RE: A&M Project # 2604-01
Comprehensive Permit Site Plan Review
Arbella at Ashland, Memorial Drive
Response to Peer Review Comments

On behalf of our Client, US Senior Manager, LLC, Allen & Major Associates Inc. (A&M) would like to provide responses, summarized below as related to a peer review memo prepared by Michael J. Carter, PE of GCG Associates, Inc., dated April 26, 2021.

Pond 3P: Stormtrap

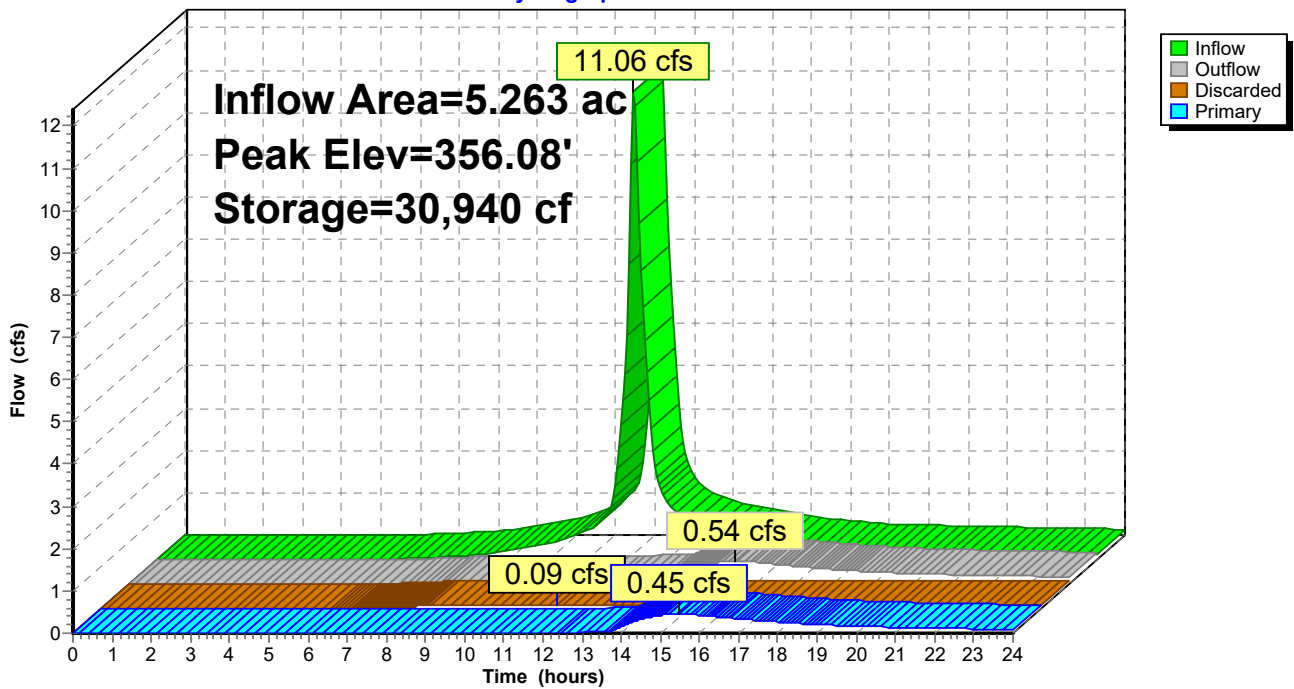
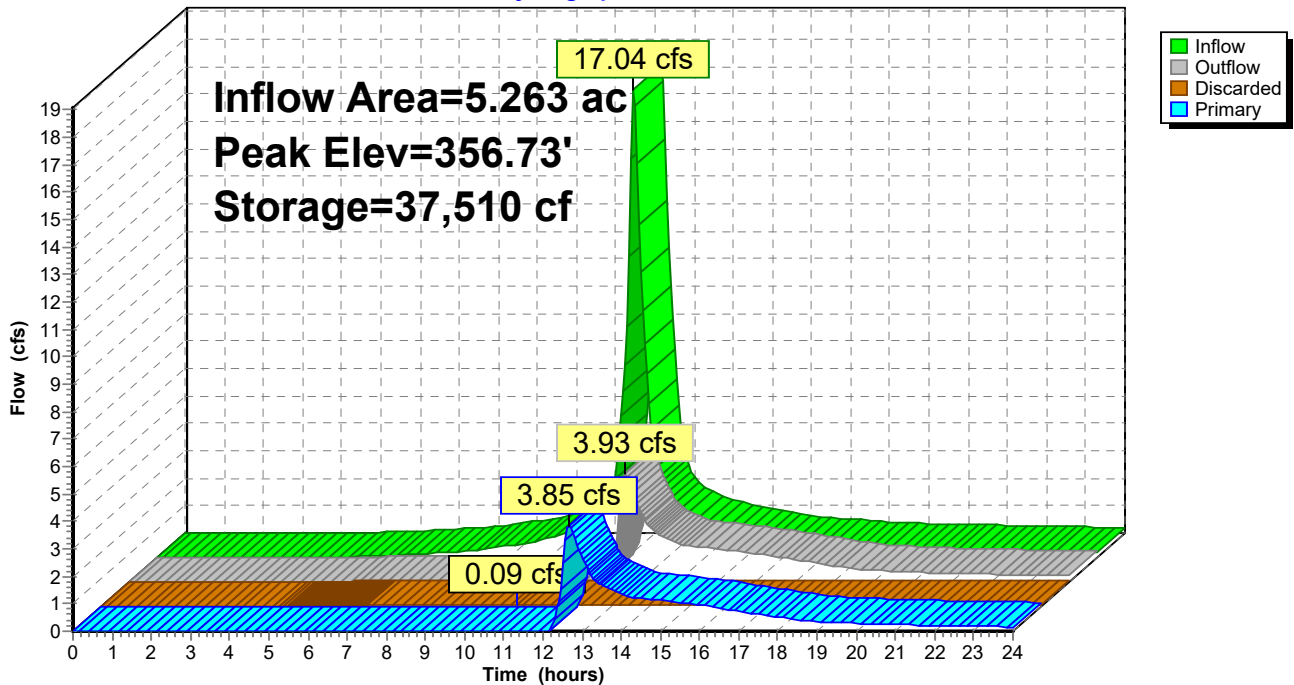
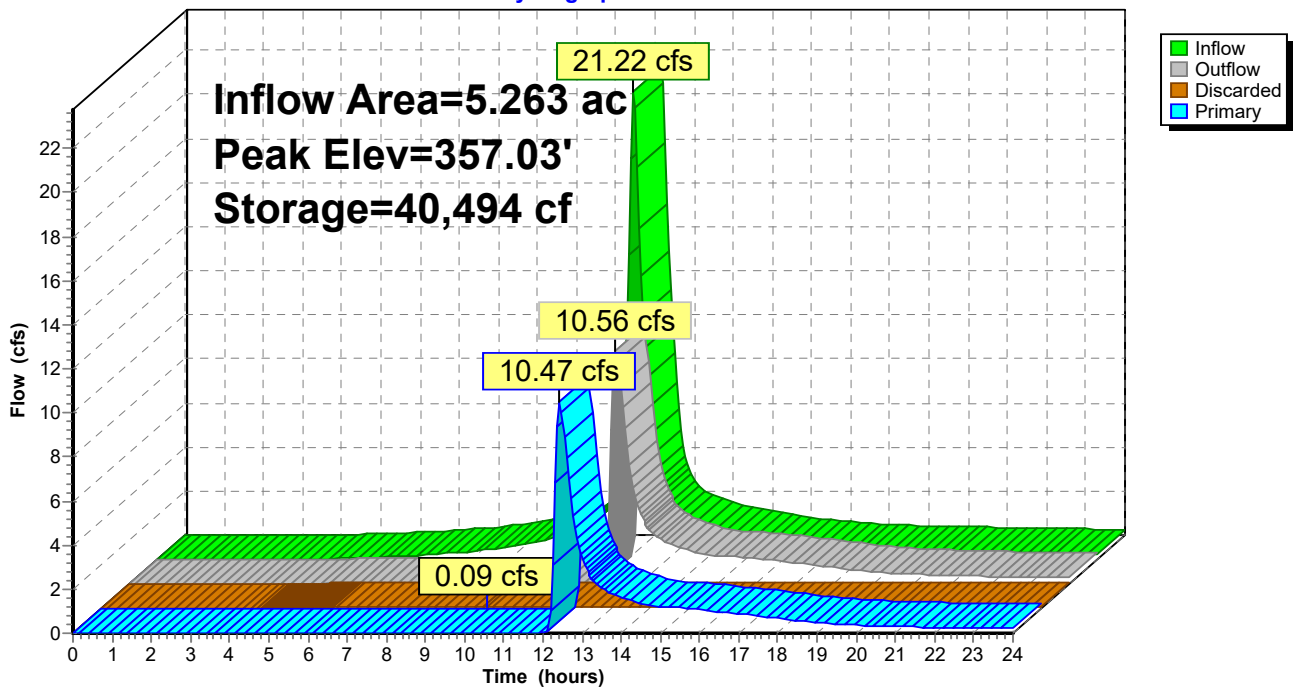
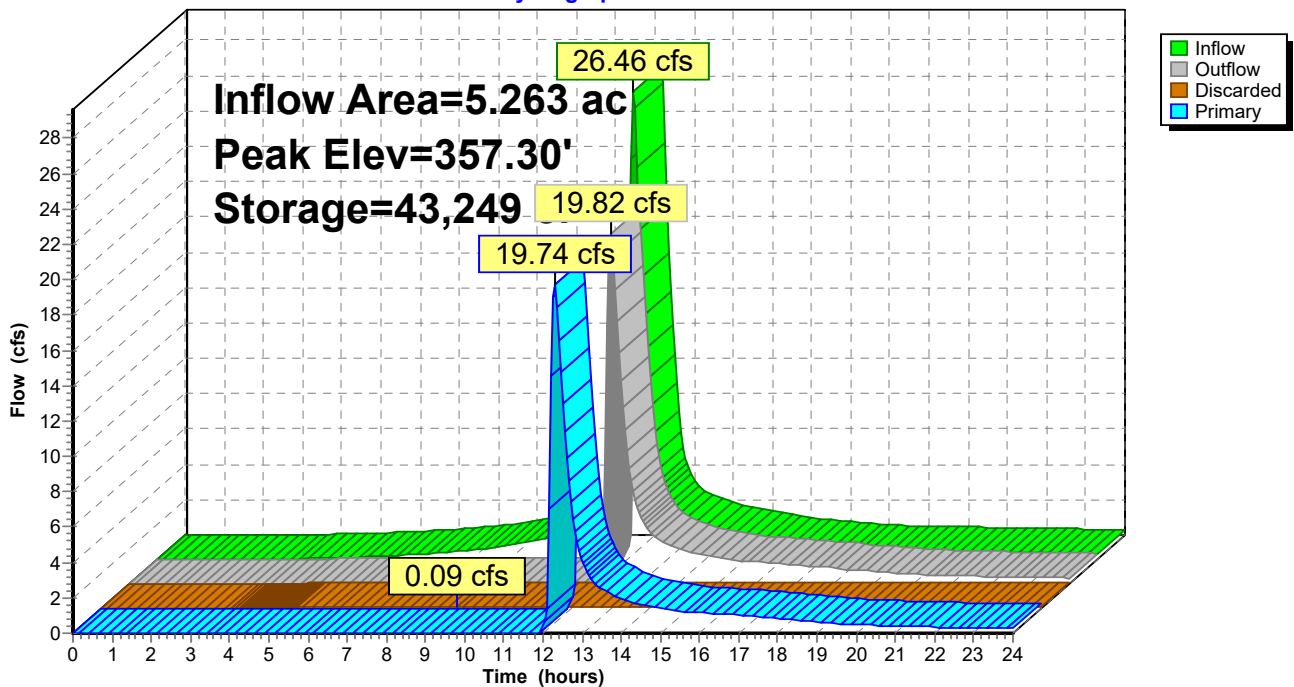
Comment 2: The revised Table 3.2.B shows a 37.2% discharge volume increase during the 100-year storm event. According to the HydroCAD report Pond 4P: Stormtrap model, the calculations were based on 40 Stormtrap chambers in 2 rows layout, which did not match the proposed 88 chambers shown on the Stormtrap Chambers detail #3 shown on plan sheet C-505. GCG recommends the applicant to utilize the Chamber Wizard option within the HydroCAD program to analysis the Stormtrap chambers application as recommended by manufacturer. The 88 chambers system should increase the storage volume significantly, which affect the discharge rate and volume.

Response 2: A&M has coordinated the Stormtrap system design with the manufacturer inclusive of appropriate modeling within HydroCAD. The manufacturer's layout is attached hereto for reference as well as updated HydroCAD watershed reports. The net result is a lessening of the discharge volume during the 100-year storm events. Below are the updated tables from the original drainage report and the updated drawdown calculation based on the reconfiguration of the subsurface field.
